World Forum for Harmonization of Vehicle Regulations

Proposal for Supplement 1 to the original version of UN Regulation No. 154

Submitted by the representatives of the European Commission and Japan *, **

"Figure 8/1

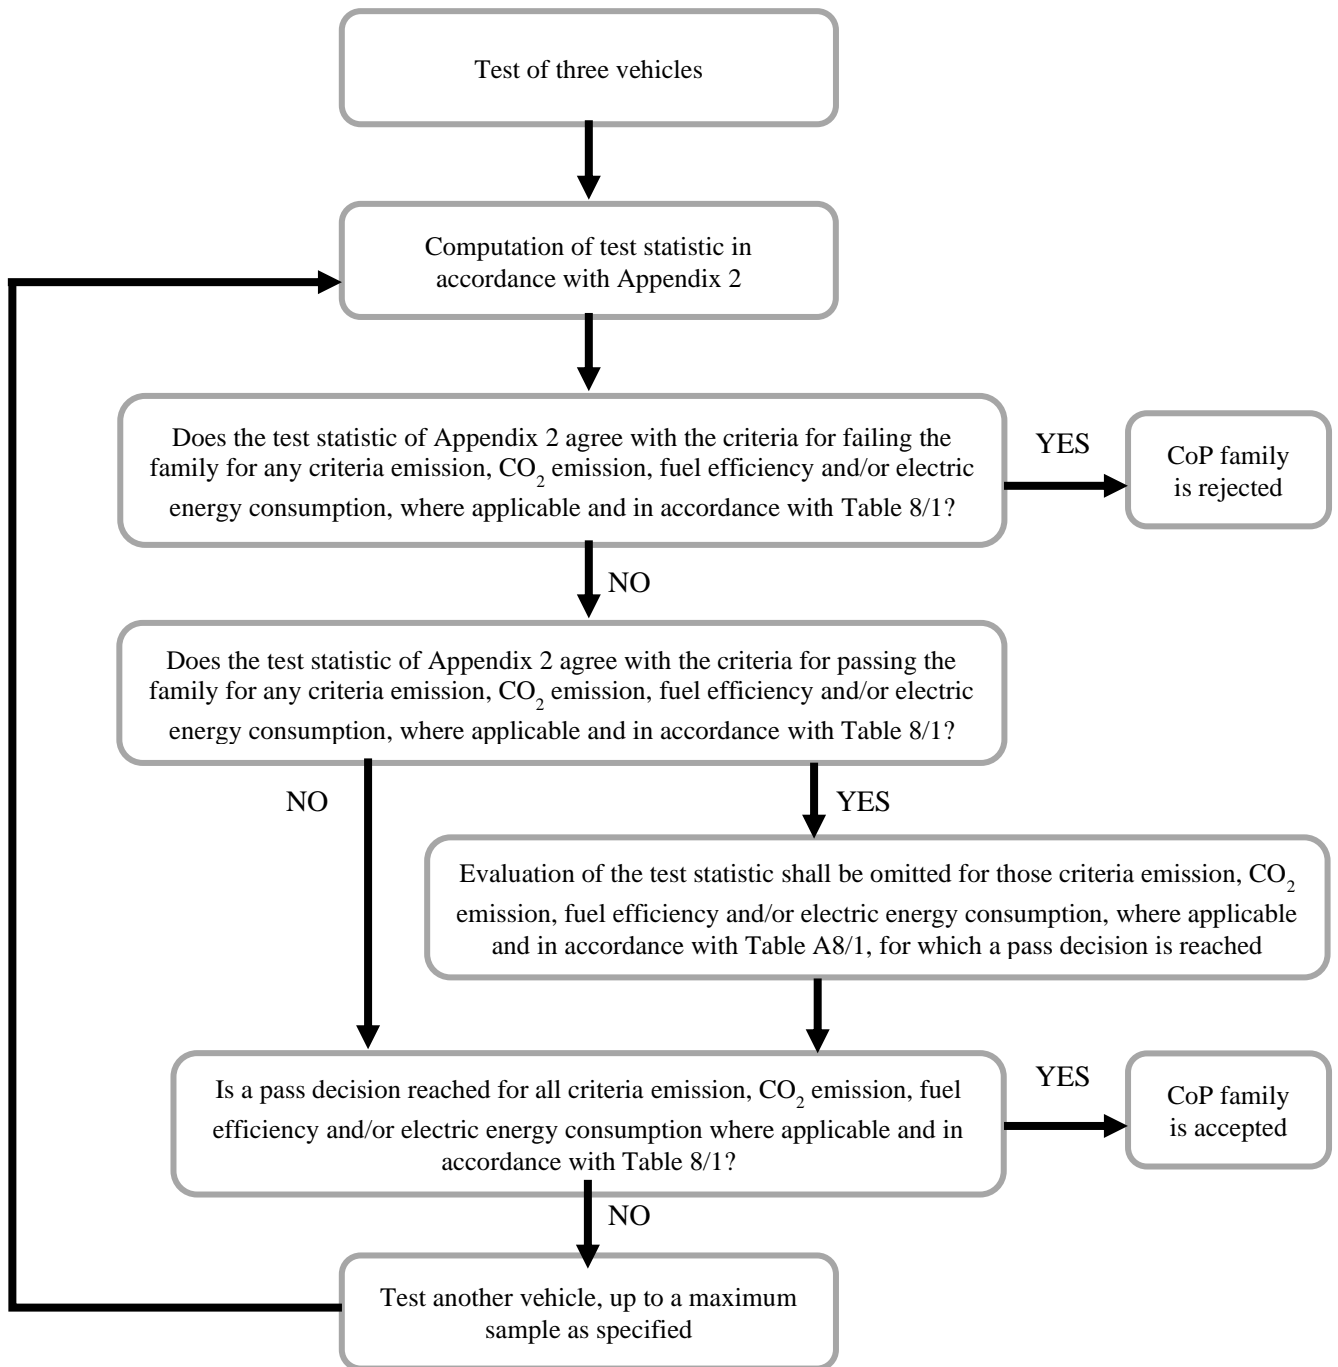
Paragraph 8.2.3.2., Figure 8/1, amend to read:

Flowchart of the CoP test procedure for the Type 1 test

Figure A6/4

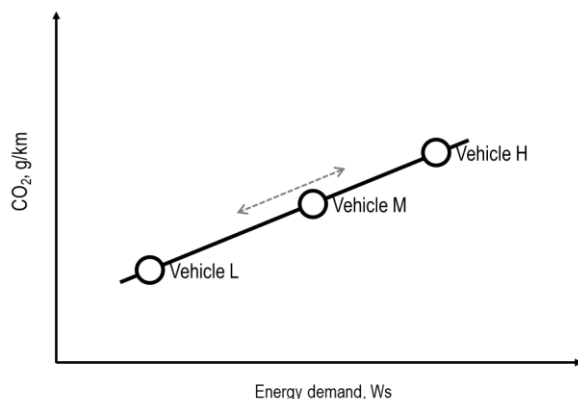
Paragraph 2.3.2.4., amend to read:

"2.3.2.4. Vehicle M is a vehicle within the interpolation family between the vehicles L and H with a cycle energy demand which is preferably closest to the average of vehicles L and H.

The limits of the selection of vehicle M (see Figure A6/4) are such that neither the difference in CO₂ emission values between vehicles H and M nor the difference in CO₂ emission values between vehicles M and L is greater than the allowed CO₂ range in accordance with paragraph 2.3.2.2. of this annex. The defined road load coefficients and the defined test mass shall be recorded.

Figure A8/2

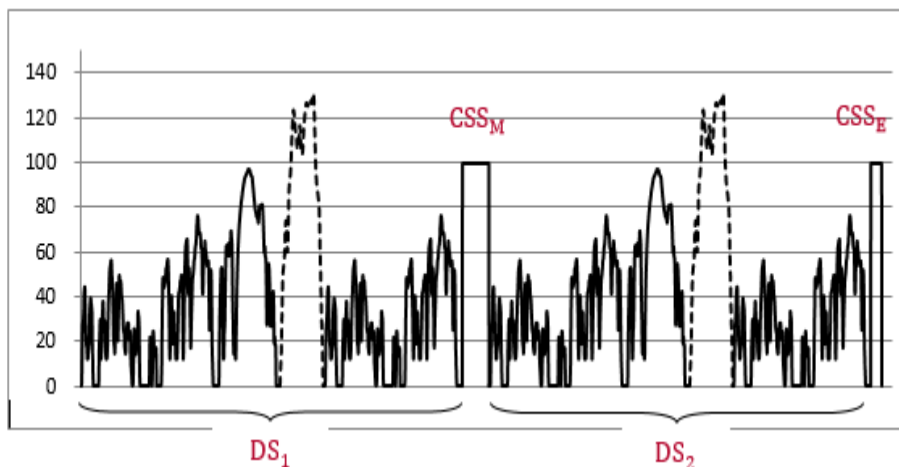
Paragraph 3.4.4.2.1., amend to read:

"3.4.4.2.1. Speed trace

The shortened Type 1 test procedure consists of two dynamic segments (DS₁ and DS₂) combined with two constant speed segments (CSS_M and CSS_E) as shown in Figure A8/2.

Shortened Type 1 test procedure speed trace

Figure A8/5

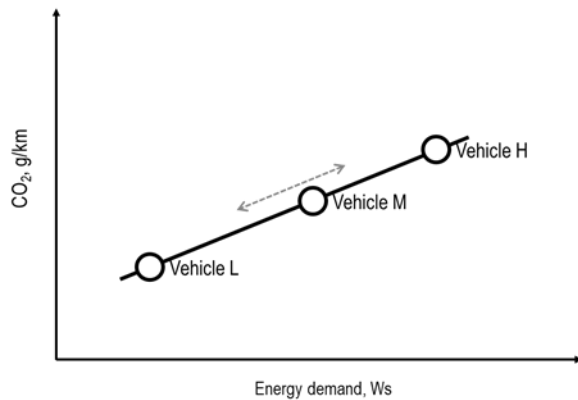
Paragraph 4.5.1.1.5., amend to read:

Vehicle M is a vehicle within the interpolation family between vehicles L and H with a cycle energy demand which is preferably closest to the average of vehicles L and H.

The limits of the selection of vehicle M (see Figure A8/5) are such that neither the difference in CO₂ mass emission between vehicles H and M nor the difference in charge-sustaining CO₂ mass emission between vehicles M and L is higher than the allowed charge-sustaining CO₂ range according to paragraph 4.5.1.1.2. of this annex. The defined road load coefficients and the defined test mass shall be recorded.
